The above plan was created by overlaying the drawings below

#### Cross Section AA

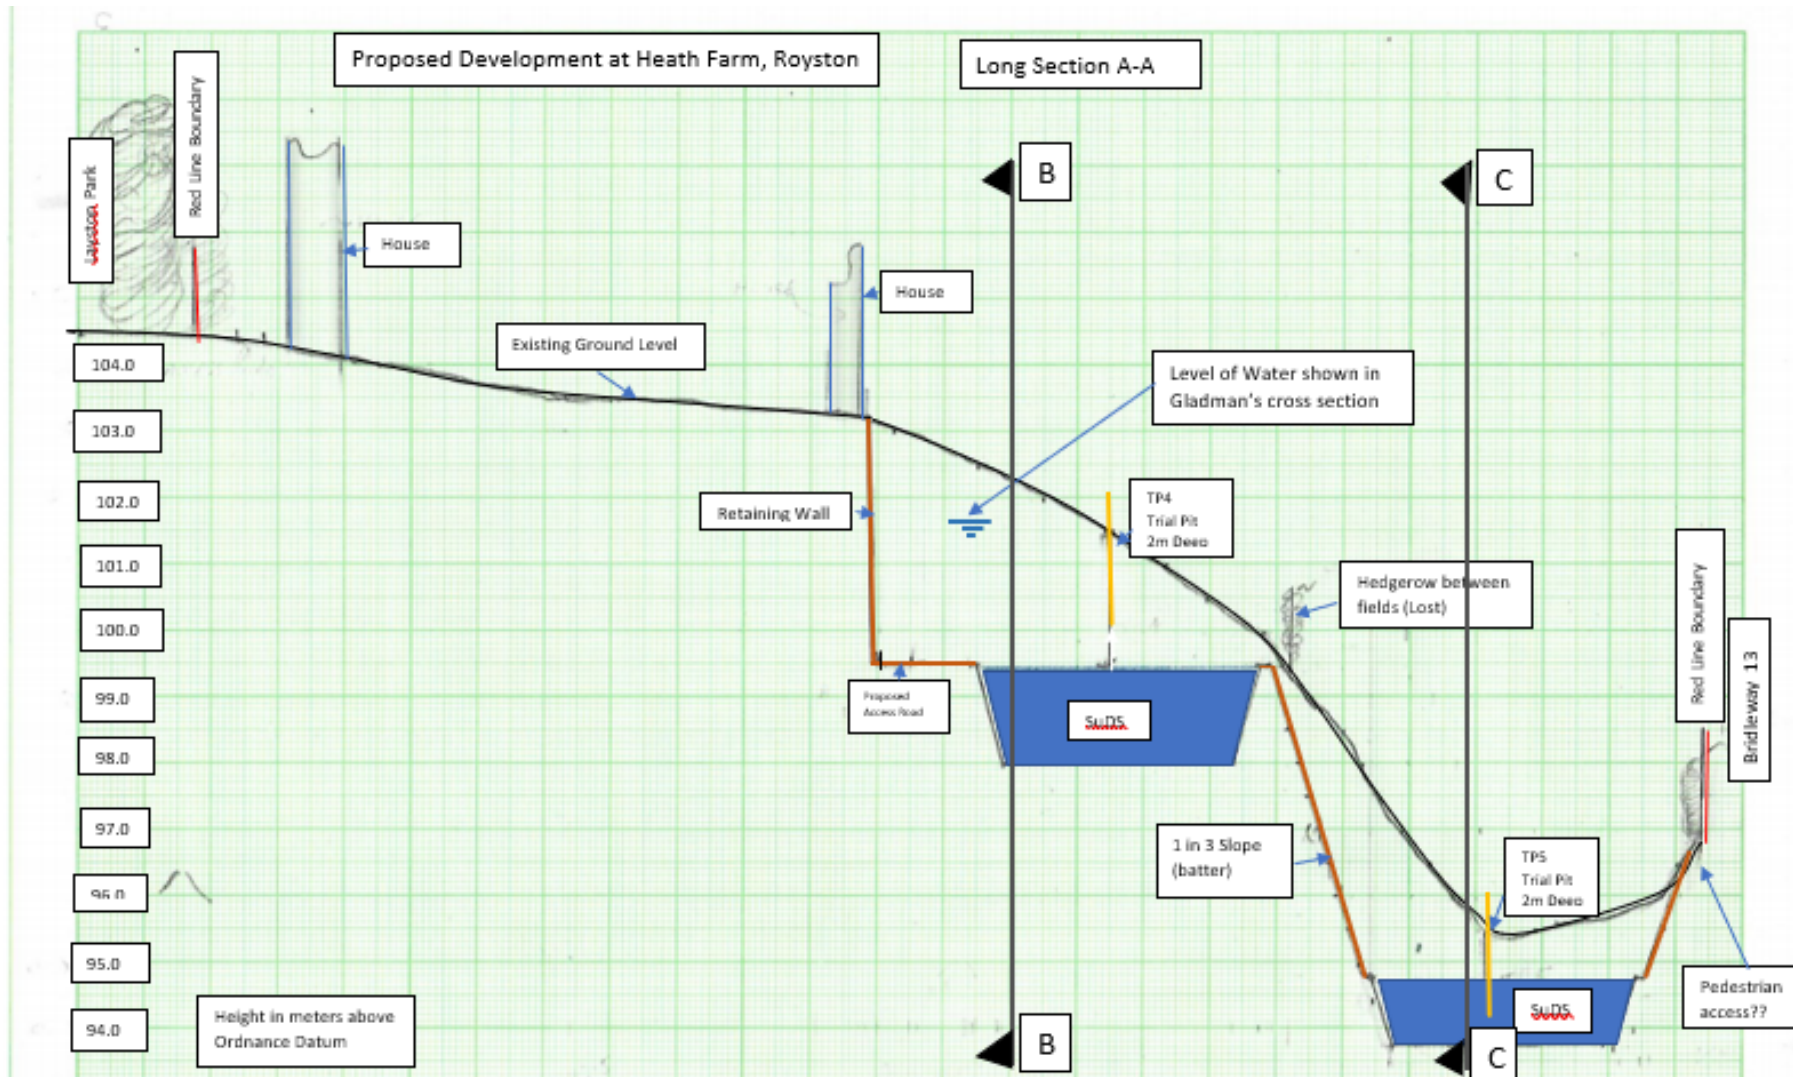
- vi) Trial Pit 4 (TP4) – 0.300m to 2.00m Structureless Chalk (MLM Flood Assessment Page 68), no insitu test sampling carried out, assumed base level of SuDS 1.53m Below Ground Level (BGL). Ground Level was approximately 102.00 AOD, SuDS invert 98.00 AOD a difference of 4m?

- vii) Trial Pit 5 (TP5) - 0.250 to 1.600m very sandy gravelly clay, 1.600m to 2.00m Structureless chalk (MLM Flood Assessment Page 69), no insitu testing carried out, assumed base level of SuDS 1.35m below ground level. Ground level was approximately 96.00 AOD, SuDS invert 93.75 AOD a difference of 2.250m

- viii) Referenced Ciria 768 Construction of SuDS, a 1.5m wide berm should be allowed at freeboard level
- ix) Gladman Site Investigation Pt 3 Page 40 records borehole information from 1960's – soft chalk

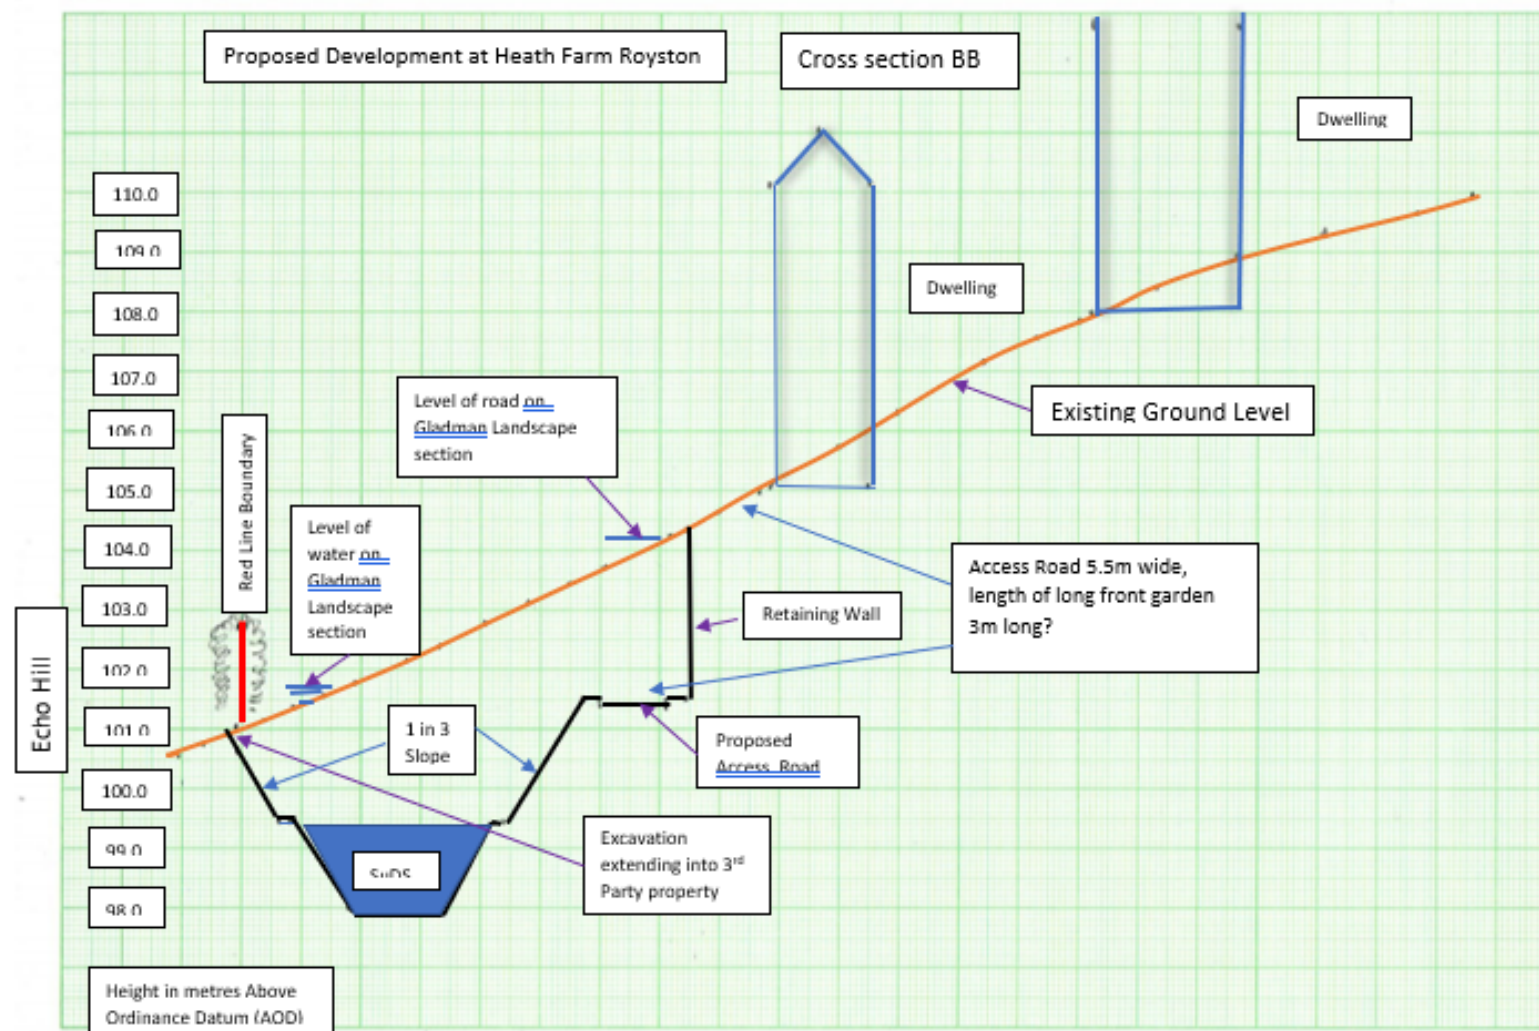
- i) Retaining wall to the left of the proposed access road is in excess of 3.5m high
- ii) Top of freeboard coincides with cross section – comment
- iii) Discharge into the SuDS off the access road to be through an interceptor tank before being discharged into the SuDS
- iv) No proposal as to how the Zone 1 water protection zone is being protected below this point (in iii )
- v) Lower SuDS undermining upper SuDS
- vi) No access into lower SuDS to maintain it
- vii) Batter running up to the Red Line on Bridleway 13 removes any access into site
- viii) Hedgerow between SuDS removed
- ix) View from Icknell Way would see the 1.5m bank to the SuDS, 3.5m+ high retaining wall and the “ Maximum dwelling height stated by Gladman of 8.5m” making a minimum height of 13.5m
- x) Excavaton for SuDS in excess of 4m

- i) Height of retaining wall approximately 2.8m ( this is using the 5% gradient stated by Hertfordshire Highways)
- ii) Width of road 5.5m, but Gladman state a long front garden is 3.0m long?
- iii) Batter (slope on north side (left) of SuDS not only removes the hedgerow but also extends into 3<sup>rd</sup> Party Properties
- iv) Levels shown in Gladman cross section are not representative of actual proposed levels ( water in the SuDS is sloping!)
- v) No retaining walls shown in Gladman proposal

#### Cross Section CC

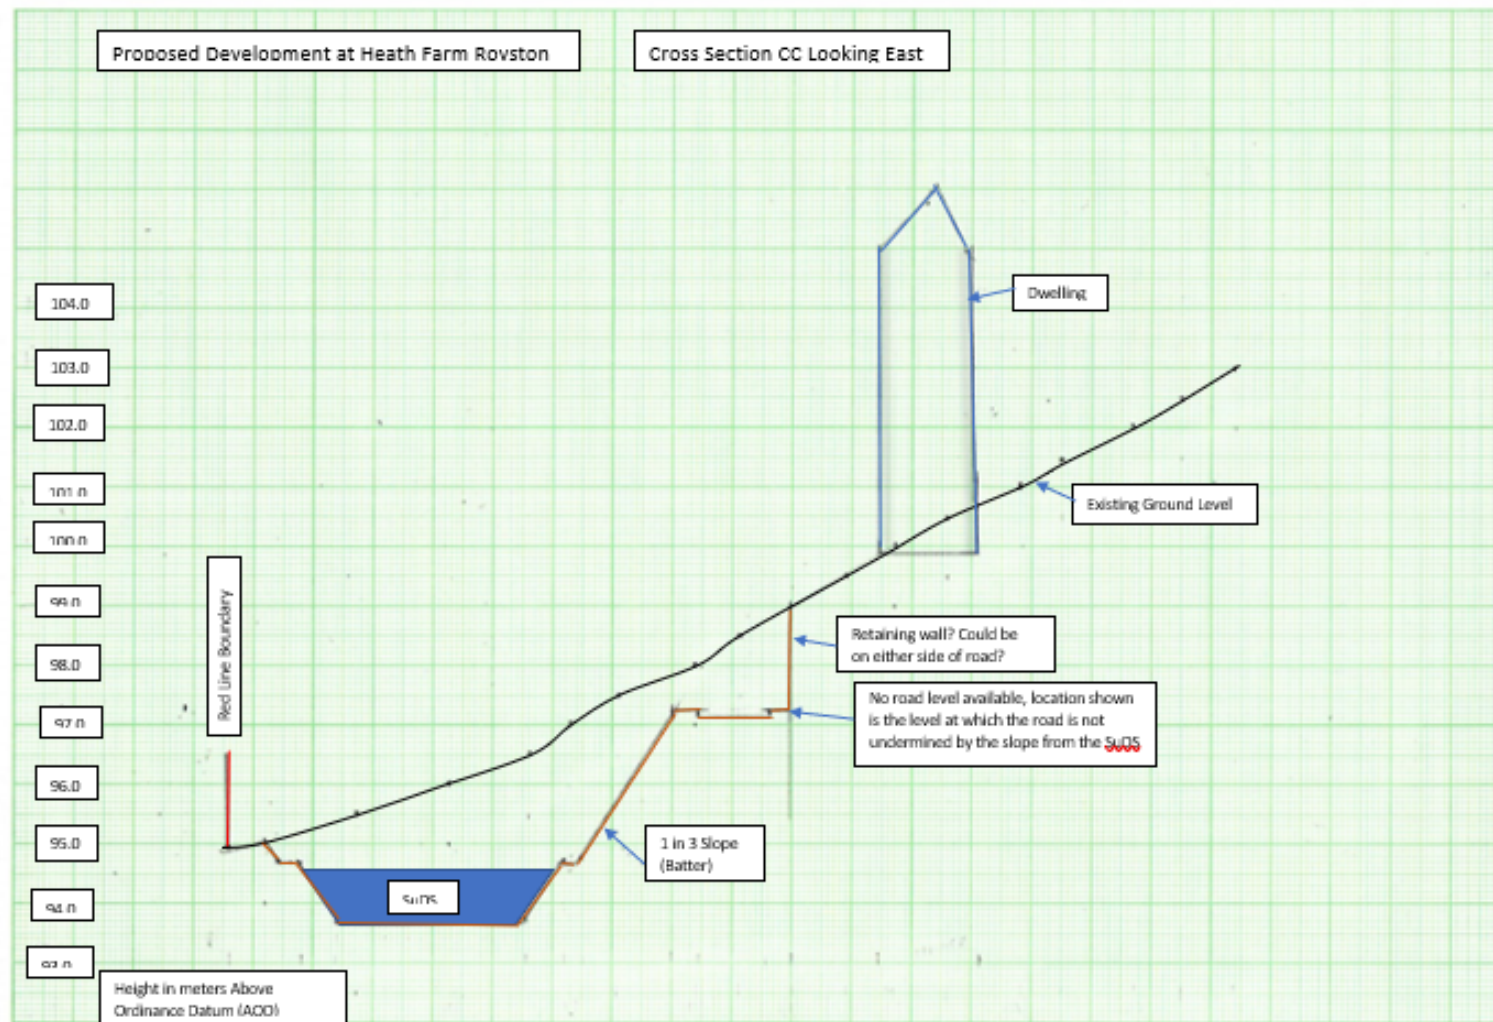
- I) Retaining wall 2m high not shown
- II) No access to maintain SuDS
- III) Retaining wall could be located on the left of the road, but this would result in a 2m vertical drop onto the 1:3 slope to the SuDS
- IV) Retaining wall could be located on the right of the road, but this would result in an unacceptable steep road running south
